Work Order ID 77337

Item Name: Crosstube Turning Detail

DART AEROSPACE LTD	Work Order:	77337
Description: Crosstube Assembly (205/212/412 High Fwd)	Part Number:	D212-664-141
Inspection Dwg: D212-664-141 Rev: D		Page 1 of 1

DRAWING NO. D212-664-141	TITLE XTUBE ASSY (205/212/412 HI FWD)	REV. D	DART AEROSPACE LTD ENGINEERING ORDER		D.E.O. NO. D212-664-141-D-1	SHEET NO. SHEET 1 OF 2	SCALE NTS
DRAWN	CHECKED	MP	MFG. APPR.	ER	APPROVED	WA	DE APPR.
DATE 11.04.07	DATE 11.04.11		DATE 11.04.12		DATE 11/04/12		DATE 11.04.12

**D212-664-141/-141B
ASSEMBLY DETAIL**

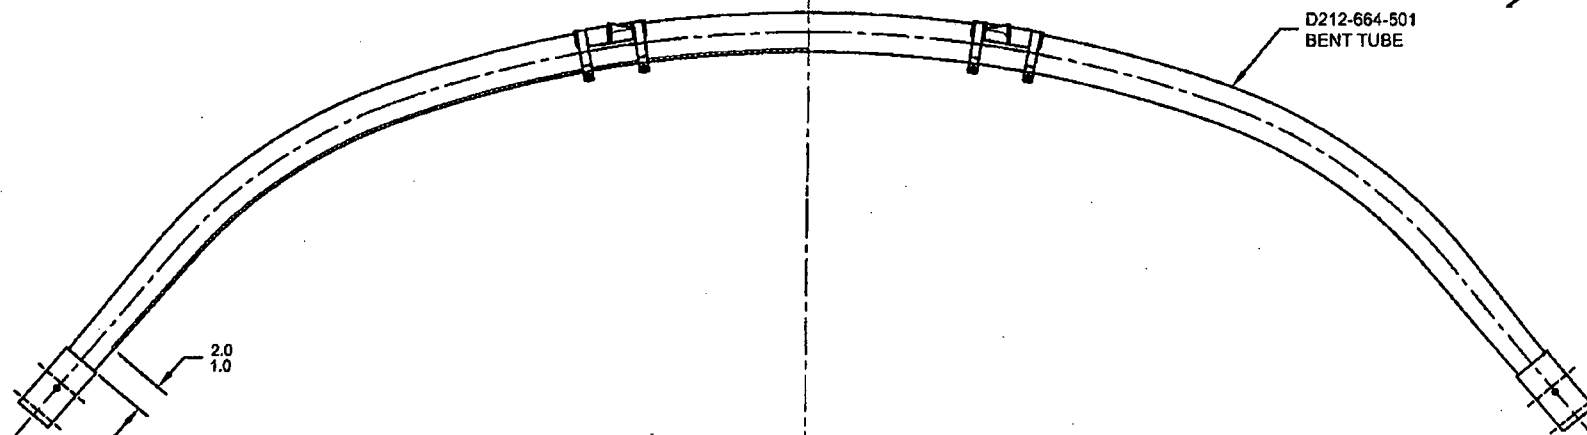
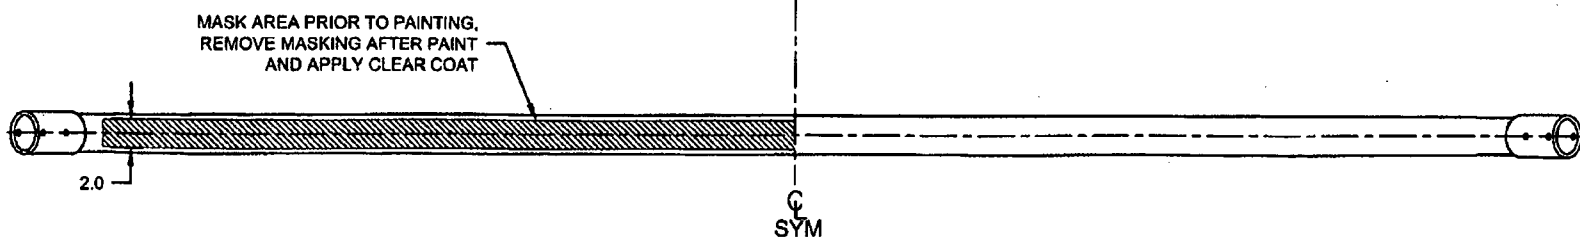
PURPOSE:

ADD AN INSPECTION WINDOW TO UNDERSIDE OF CROSSTUBE.

NOTES 2 OF SHEET 1 IS AMENDED AS FOLLOWS:

- 2) FINISH: CHEMICAL CONVERSION COAT PER DART QSI 005 4.1
PRIME INSIDE AND OUTSIDE PER DART QSI 005 4.2
MASK UNDERSIDE OF CROSSTUBE AS SHOWN (HATCHED AREA) AND
PAINT OUTSIDE PER DART QSI 005 4.2
REMOVE MASKING AND APPLY CLEAR COAT

- 2) FINISH: CHEMICAL CONVERSION COAT PER DART QSI 005 4.1
PRIME INSIDE AND OUTSIDE PER DART QSI 005 4.2
PAINT OUTSIDE PER DART QSI 005 4.2
